Title		IR KEYBOARD RECEIV
Size	Number	
B		51-000-0008
Date:		13-Jul-1999
File:		C:\CLIENT\1000-0008 SCH

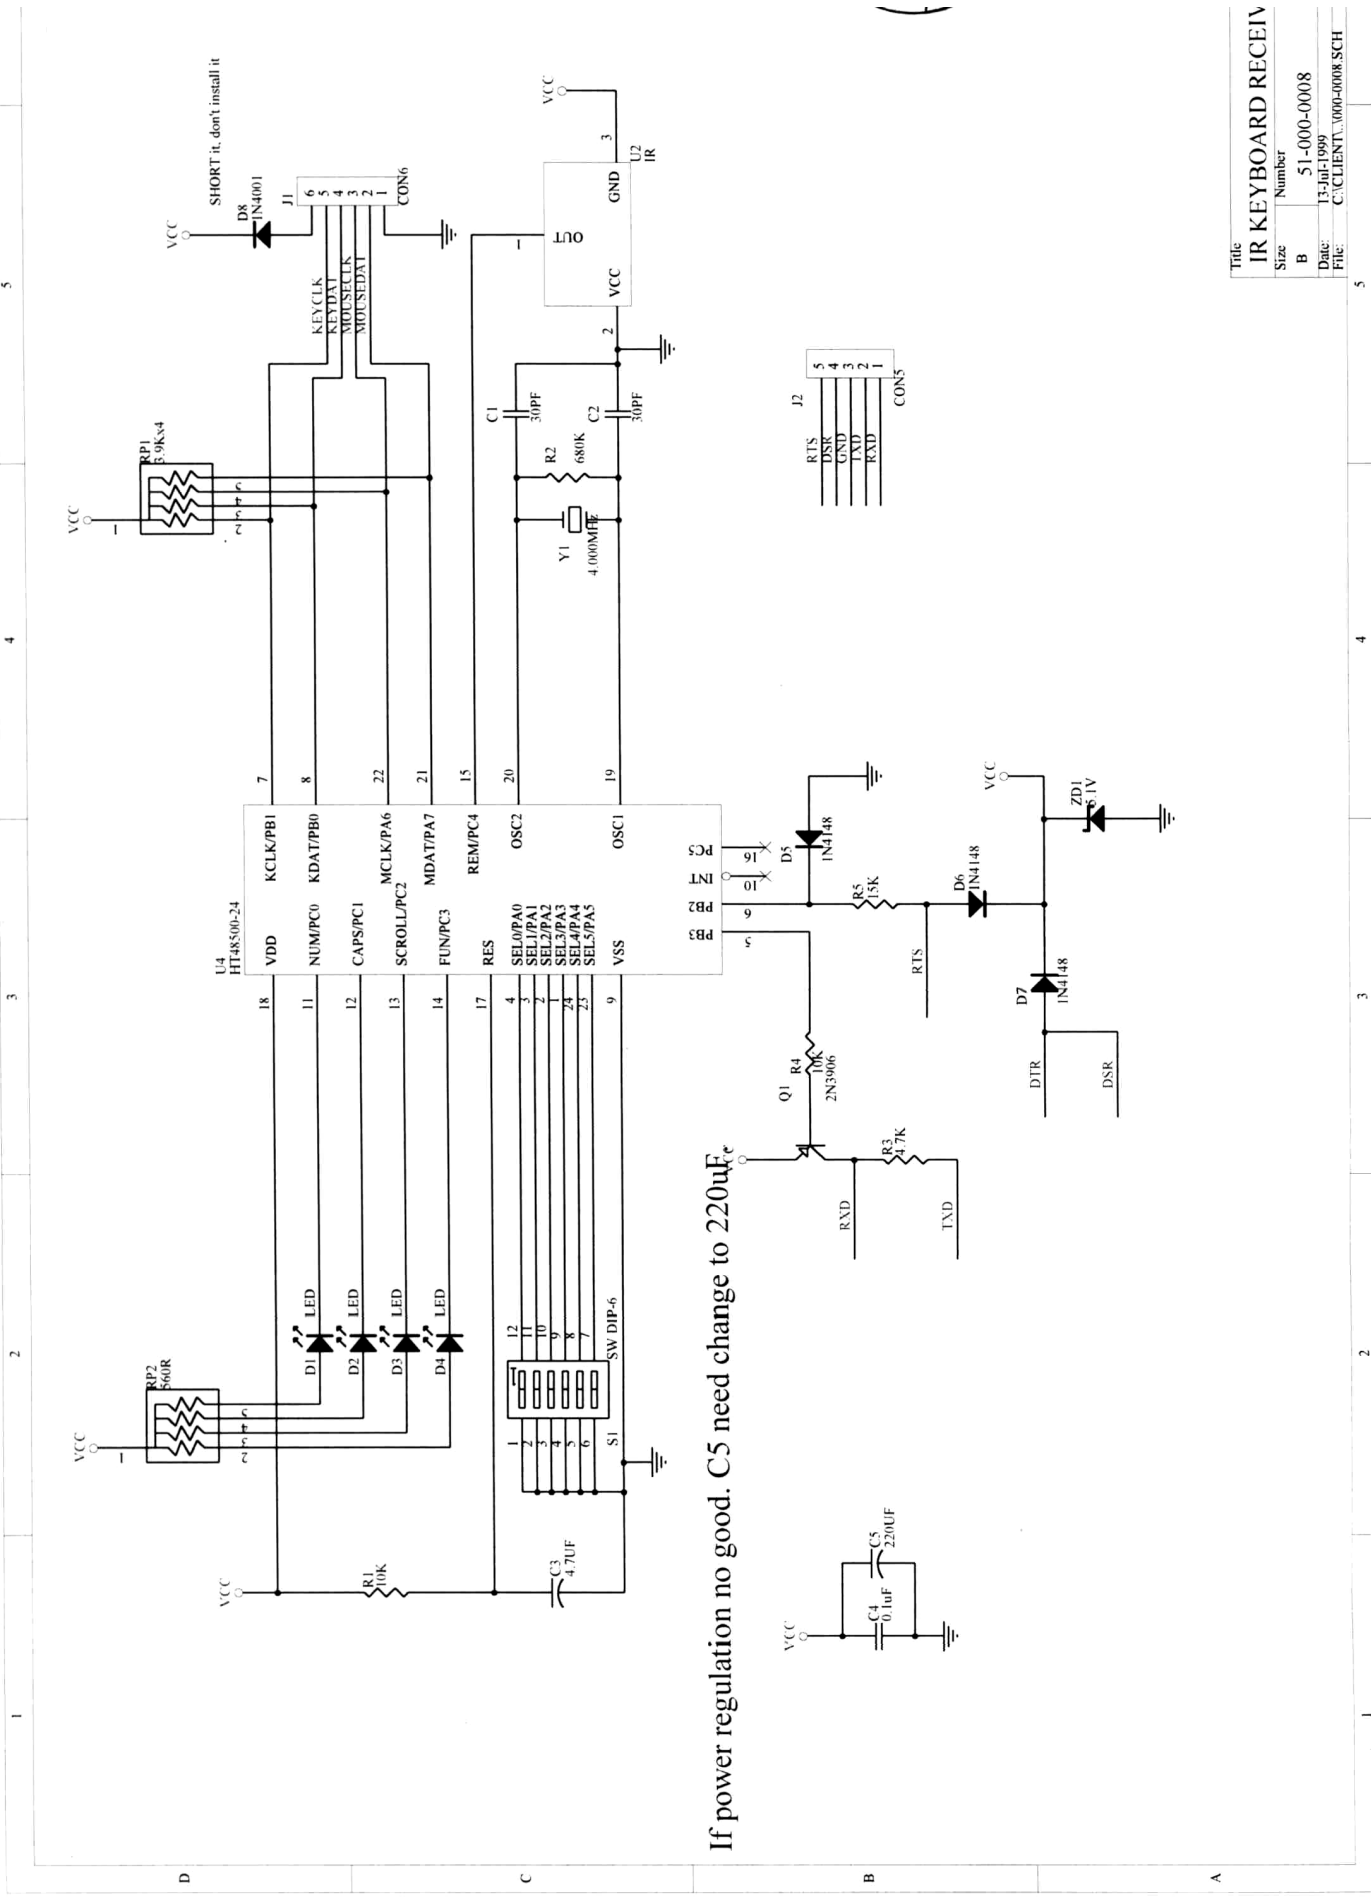
If power regulation no good. C5 need change to 220uF.
